**STAFF RECOMMENDATION**

**206 Carden Avenue**  
**December 16, 2020**

**Application:** New Construction—Addition; Partial Demolition  
**District:** Whitland Neighborhood Conservation Zoning Overlay  
**Council District:** 24  
**Base Zoning:** RS7.5  
**Map and Parcel Number:** 10413005100  
**Applicant:** Brittney Mount, Allard Ward Architects  
**Project Lead:** Melissa Baldock, melissa.baldock@nashville.gov

<p><b>Description of Project:</b> Application is to remove an existing, non-contributing addition and to construct a new rear addition.</p> <p><b>Recommendation Summary:</b> Staff recommends approval of the project with the condition that staff approve a masonry sample, all windows and doors, the roof materials, and the location of the HVAC unit prior to purchase and installation. With this condition, staff finds that the proposed addition meets Sections II.B.1., II.B.2., and III.B. of the design guidelines for the Whitland Neighborhood Conservation Zoning Overlay.</p>	<p><b>Attachments</b> <b>A:</b> Site Plan <b>B:</b> Elevations</p>
---	--

Figure 2 (Left) is the drawing for the porch permit and Figure 3 (Right) shows the porch as seen from the street.

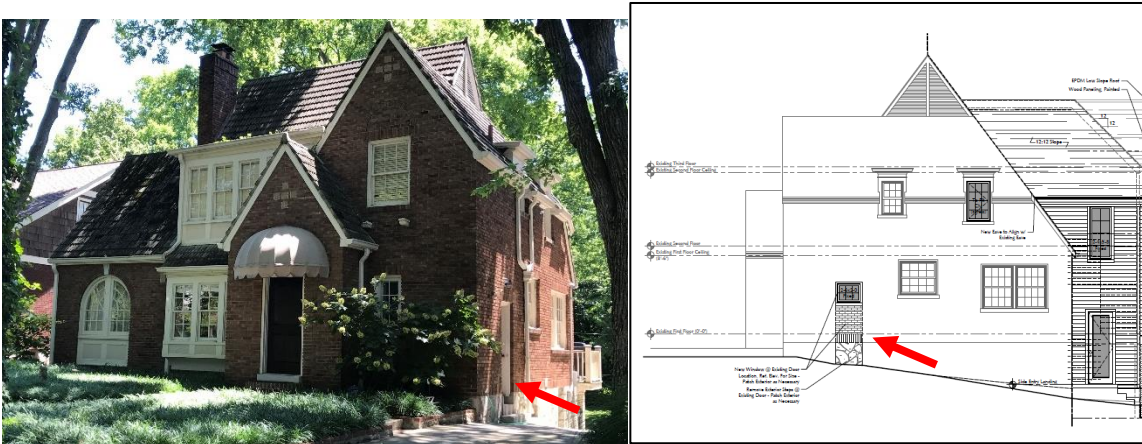
Demolition: The applicant proposes to remove an existing rear porch and to alter window and door openings, which is considered partial demolition. According to Codes, the porch was constructed in 2011 (Figures 2 & 3). Because the addition is less than ten years old, it is not considered to be a contributing part of the historic house and its removal therefore meets the design guidelines.

Staff finds that the removal of the rear porch and the alteration of the door into a window meets Section III.B.2. of the design guidelines.

Figure 4 (Left) shows the existing door and Figure 5 (Right) shows the proposed window opening in its place.

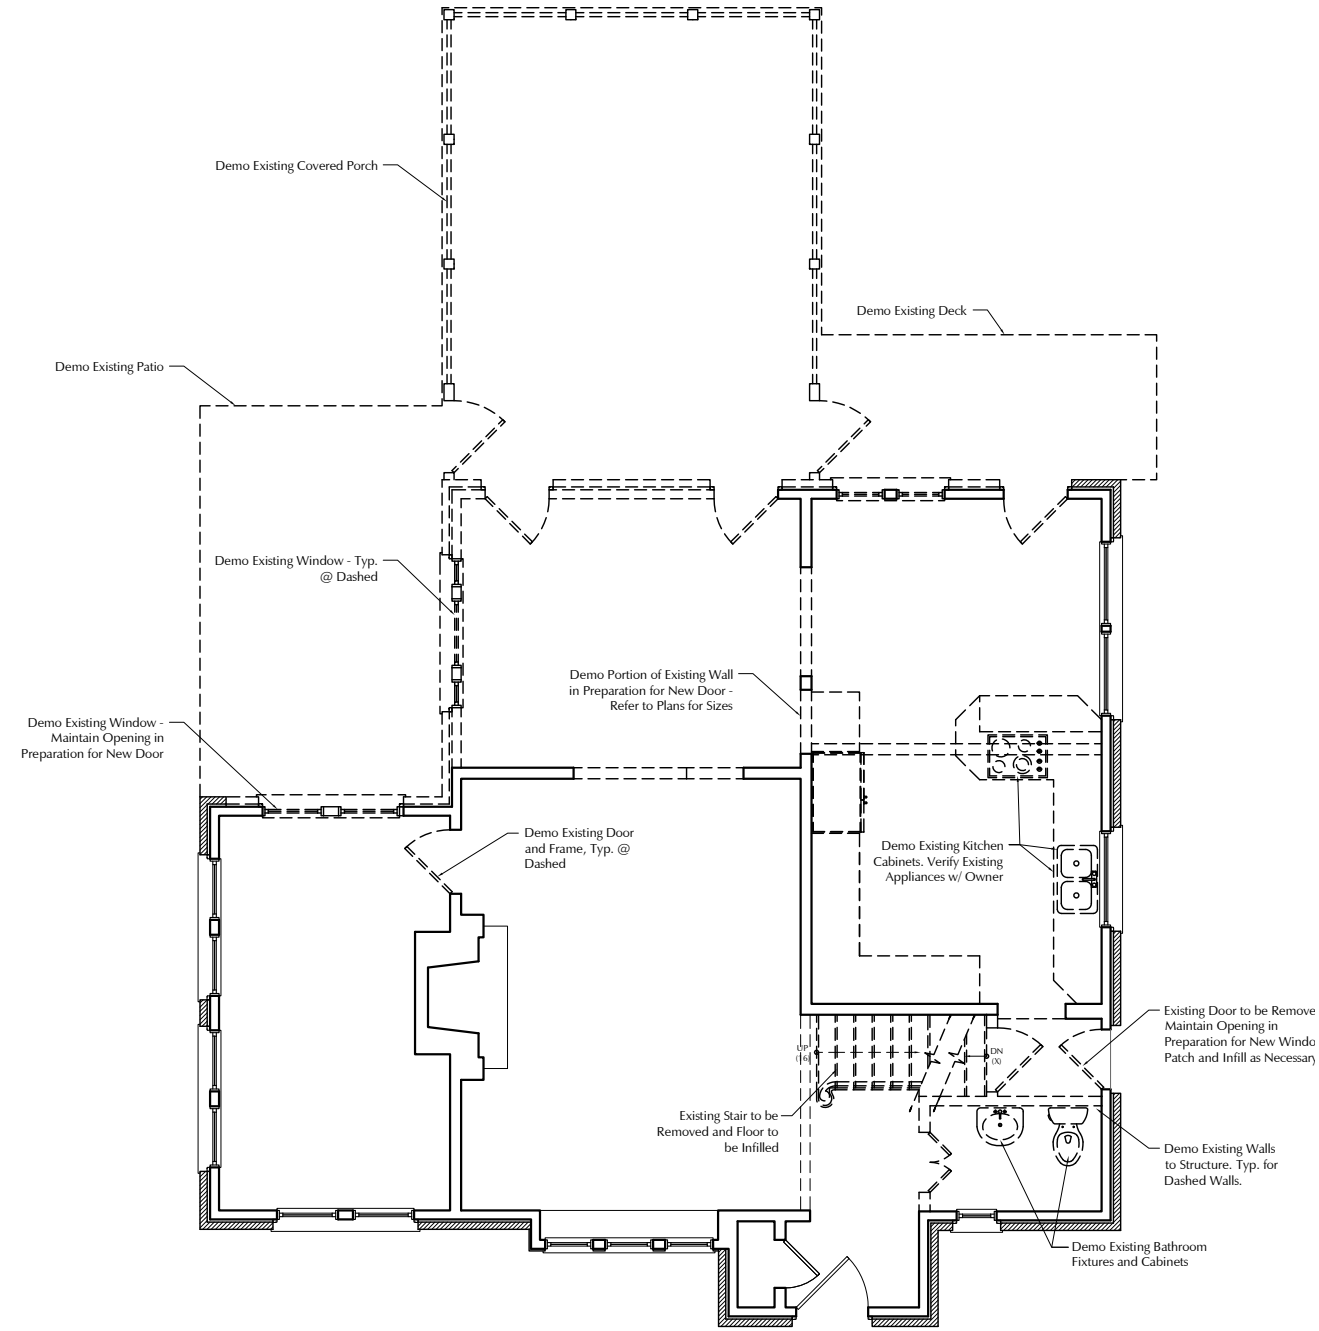
The applicant also proposes to change a door opening to a window on the right façade. Although the Commission typically discourages alteration of window and door openings on front and side facades, staff finds that this door opening is likely not original and that its alteration is appropriate partial-demolition. Staff also finds that the proposed window opening meets the design guidelines because smaller squarish windows are found on side facades in similar locations, often near chimneys.
